**Brookvale Oval Redevelopment Project**

**TTW response to Northern Beaches Council Stormwater Queries**

**DRAINS Results- 5% AEP storm event**

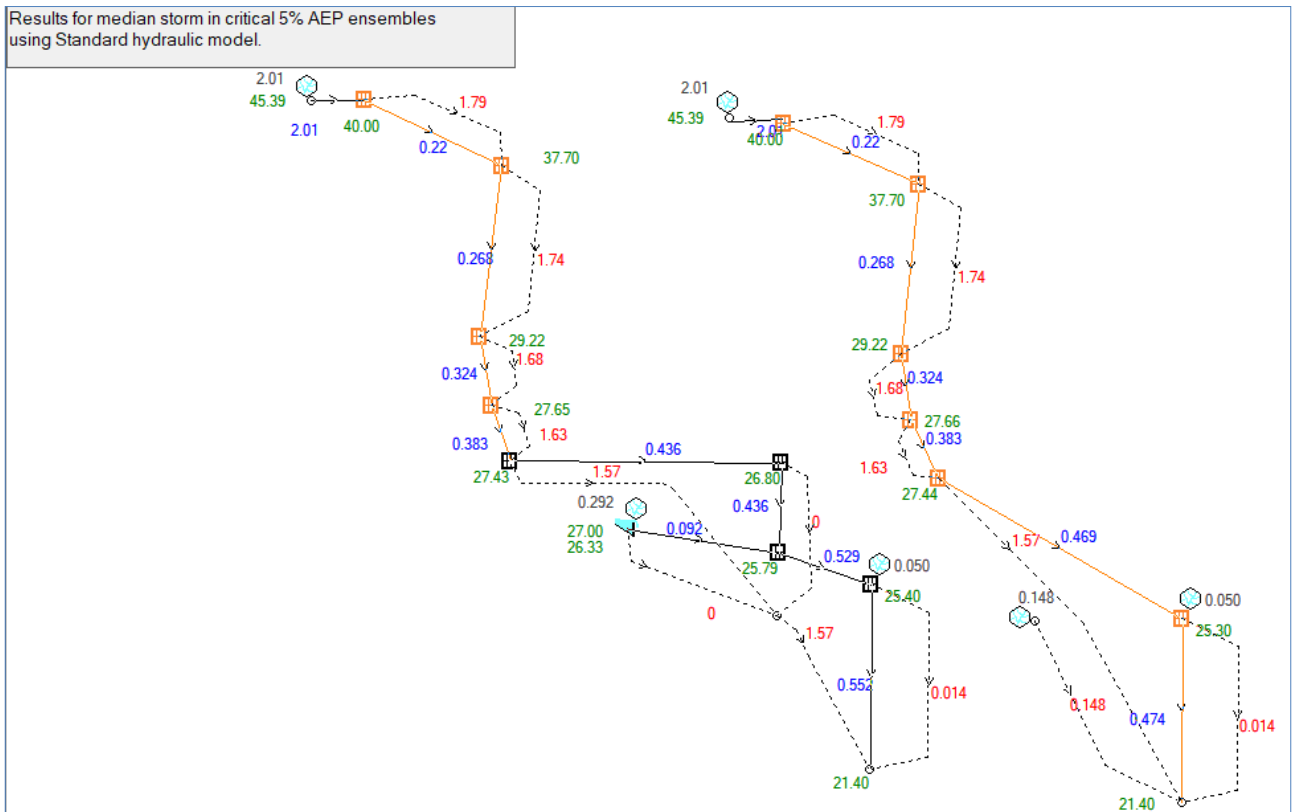
Query	TTW Response
<p>1. The proposed stormwater re diversion does not propose any upgrade from the existing scenario. It is noted that PLM advice and in accordance with Councils Water Management Policy the existing council drainage line to be re diverted is to be upgraded to cater for the 20-year storm event.</p>	<p>We are not upgrading the pipe as the 600mm pipe caters for the 20-year storm event flow. We understand the pipe system should cater for the 20-year ARI storm event from Council's AUS-SPEC 1 – D5 Stormwater Drainage Design.</p> <p>Refer to the long section exported from the DRAINS model. As shown, the HGL is at 27.38m at the upstream end of the pipe, which is within the 600mm pipe and has a maximum pipe flow of 0.436 m<sup>3</sup>/s.</p>
<p>2. The submitted information including DRAINS model is not sufficient. Additional information is recommended in order to determine catchment properties, including pipe flows and overland flow extents which may impact the proposed development.</p>	<p>The upstream catchment has been determined based on Google Earth data in conjunction with the Northern Beaches Council drainage map. Refer to the screenshots below.</p> <p>Also attached is the latest DRAINS model which has the upstream catchment modelled in both pre-development and post-development scenarios, which incorporates Council's existing drainage from Binba Place towards the development site. The upstream catchment is modelled to have a 60% impervious area. This drainage analysis illustrates that the proposed development does not negatively impact the downstream conditions in comparison with the pre-development conditions. The site includes effective overland flow paths incorporated around the site for the 100-year storm event to ensure overland flows do not impact the development.</p>

### Northern Beaches Council Drainage Map

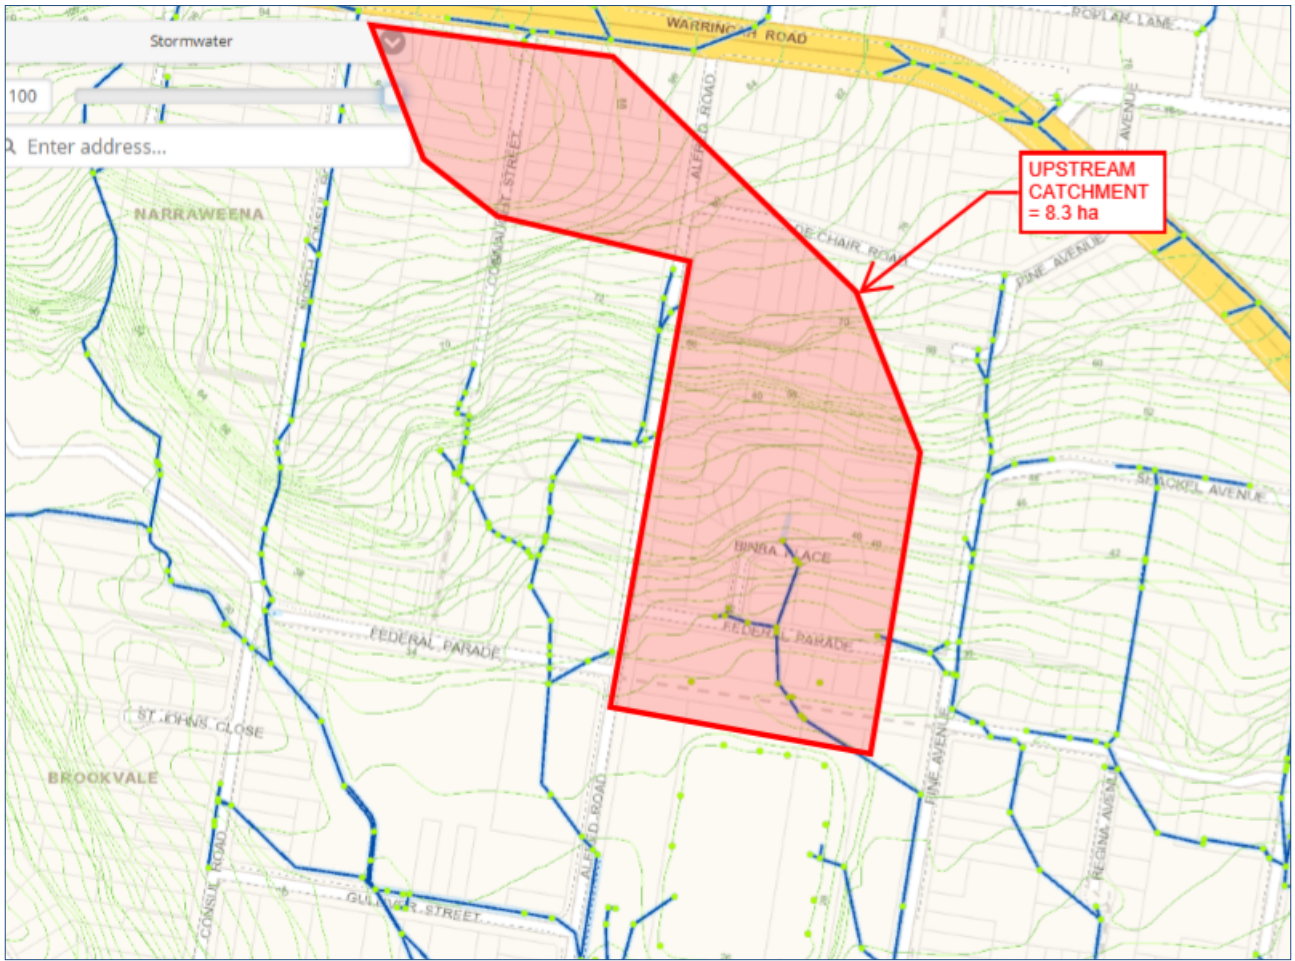
<p>3. Catchment maps, including sub-catchments for the existing council drainage infrastructure. The DRAINS model should be amended to accurately reflect catchment characteristics and is to include the pipe network.</p>	<p>The catchment area is shown in the Council's drainage map. The DRAINS model includes the upstream catchment and pipe network.</p>
<p>4. The DRAINS model is to include the capacity of existing and proposed Council drainage infrastructure with appropriate blockage factors as specified in Councils Auspec one design standard.</p>	<p>The DRAINS model complies with Council's AUS-SPEC 1 and applies the appropriate blockage factors.</p>
<p>5. Submission of plans clearly indicating pre-development and post-development flow path extents for the 1% AEP storm</p>	<p>The pre-development overland flow is 2.57 m<sup>3</sup>/s. Refer to cross section below.</p> <p>The post-development overland flow is 2.42 m<sup>3</sup>/s. Refer to cross section below.</p>

**Post-development Council Pipe Long-section**

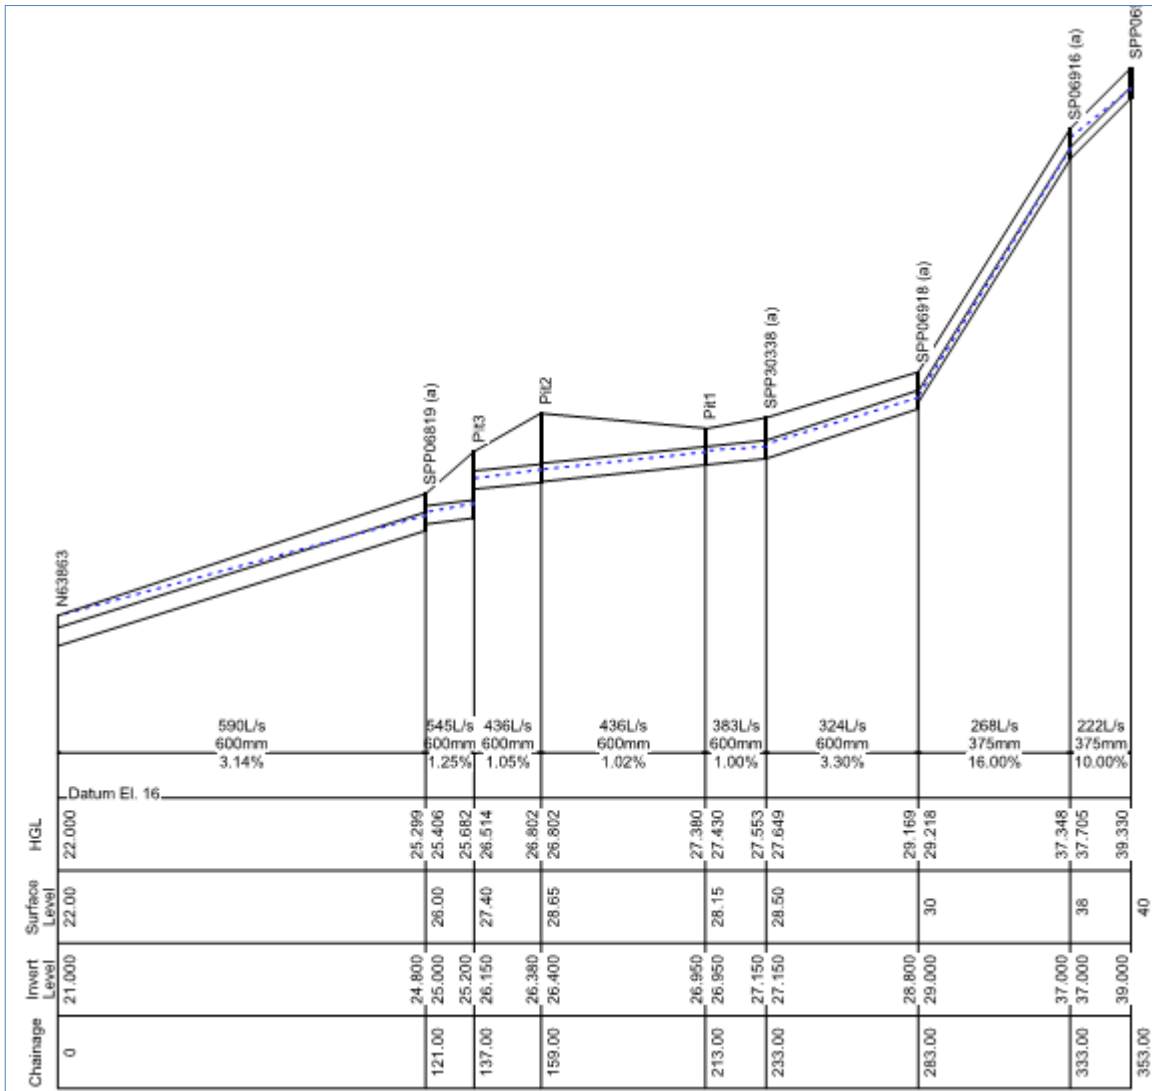
<p>6. The supporting longitudinal and cross-sectional information at appropriate intervals, including at the upstream and downstream property boundaries of the pre and post development water surface profiles to the 1% AEP.</p>	<p>Refer to the pre-development and post-development long-section of Council's pipe from upstream to downstream shown below.</p>
<p>7. Provision of any stormwater models (DRAINS, HEC-RAS) used in assessment, and relevant supporting input and output information.</p>	<p>The DRAINS model, stormwater plan, catchment area on Council's drainage map are attached.</p>
<p>8. Demonstration of compliance with Council's AUSPEC 1.</p>	<p>We are complying with the intent of Council's AUS-SPEC 1.</p>
